**Re: California Independent System Operator Corporation
Compliance Filing
Docket No. ER10-1706-000**

**Attachment A – Clean
IRRP Compliance Filing
California Independent System Operator Corporation
Fifth Replacement FERC Electric Tariff**

Attachment B – Marked Tariff
IRRP Compliance Filing
California Independent System Operator Corporation
Fifth Replacement FERC Electric Tariff

Figure 1

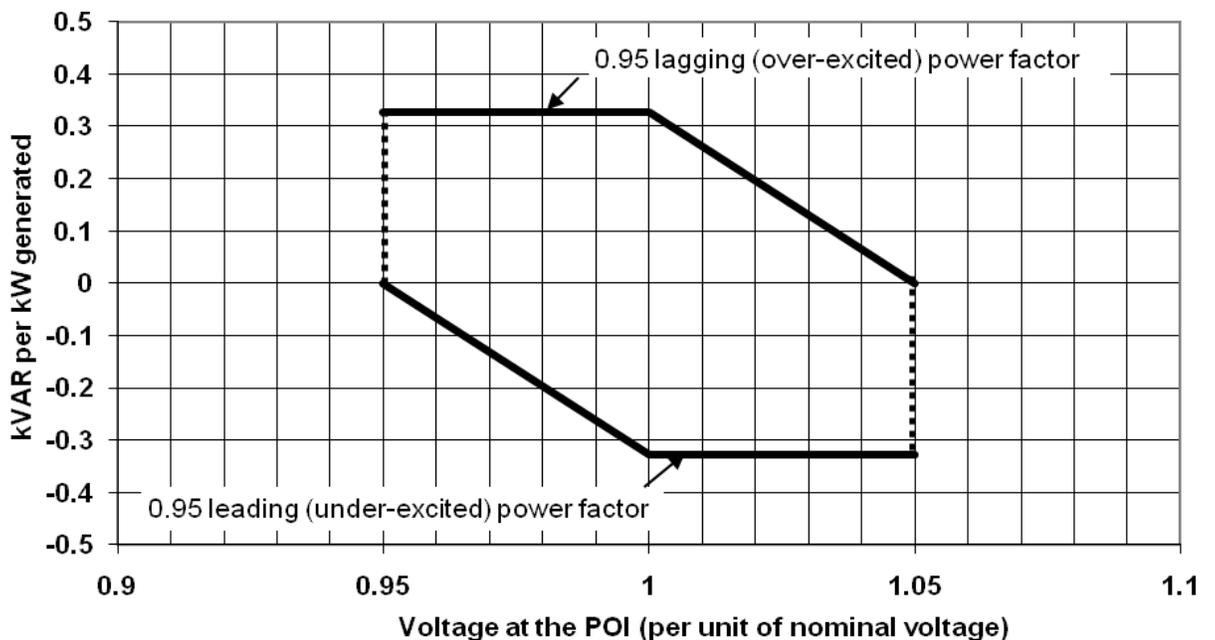
~~1. Asynchronous Generating Facilities shall meet the following design requirements:~~

- ~~a. An Asynchronous Generating Facility shall be designed to have sufficient reactive power sourcing capability to achieve a net power factor of 0.95 lagging or less at the Point of Interconnection, at the Generating Facility's maximum Generating Facility Capacity. An Asynchronous Generating Facility shall be designed to have net reactive power sourcing and absorption capability sufficient to achieve or exceed the net reactive power range in Figure 1 as a function of the Point of Interconnection voltage, without exceeding the ratings of any equipment in the Asynchronous Generating Facility. The Point of Interconnection voltage is specified in per-unit of the nominal voltage.~~

- ~~a. Net power factor shall be measured at the Point of Interconnection as defined in this LGIA.~~
- ~~a. Asynchronous Generating Facilities may meet the power factor range requirement by using power electronics designed to supply the required level of reactive capability (taking into account any limitations due to voltage level and real power output) or fixed and switched capacitors, or a combination of the two.~~

- Delete Article 9.6.2.2 pertaining to voltage control and governor control for asynchronous generating facilities.
- Modify Appendix H, Section A.i to provides an exemption for asynchronous generating facility if it can demonstrate to the ISO a binding commitment as of July 3, 2010 to purchase inverters for thirty (30) percent or more of the Generating Facility's maximum Generating Facility Capacity that are incapable of complying with the requirements.
- Modify Appendix H, Section A.iii to delete proposed tariff language relating to power factor design and operating requirements and include existing tariff

language relating to power factor design criteria from the ISO's currently approved large generator interconnection requirements for wind generators.

Figure 1

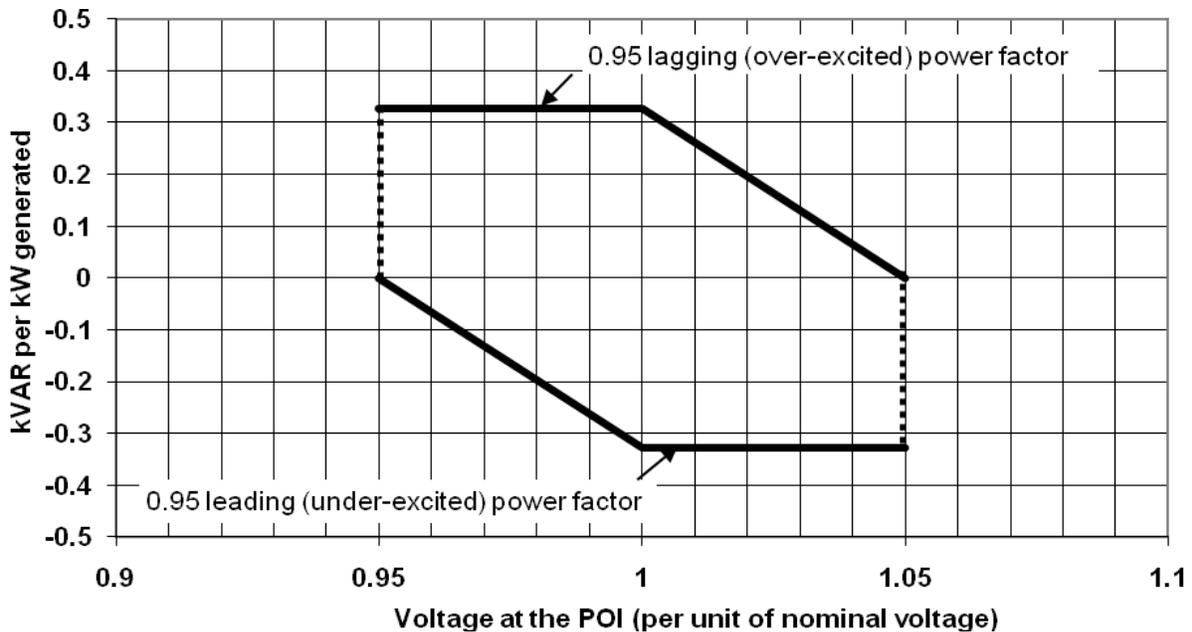
2.—Asynchronous Generating Facilities shall meet the following design requirements:

b.—An Asynchronous Generating Facility shall be designed to have sufficient reactive power sourcing capability to achieve a net power factor of 0.95 lagging or less at the Point of Interconnection, at the Generating Facility's maximum Generating Facility Capacity. An Asynchronous Generating Facility shall be designed to have net reactive power sourcing and absorption capability sufficient to achieve or exceed the net reactive power range in Figure 1 as a function of the Point of Interconnection voltage, without exceeding the ratings of any equipment in the Asynchronous Generating Facility. The Point of Interconnection voltage is specified in per-unit of the nominal voltage.

b.—Net power factor shall be measured at the Point of Interconnection as defined in this LGIA.
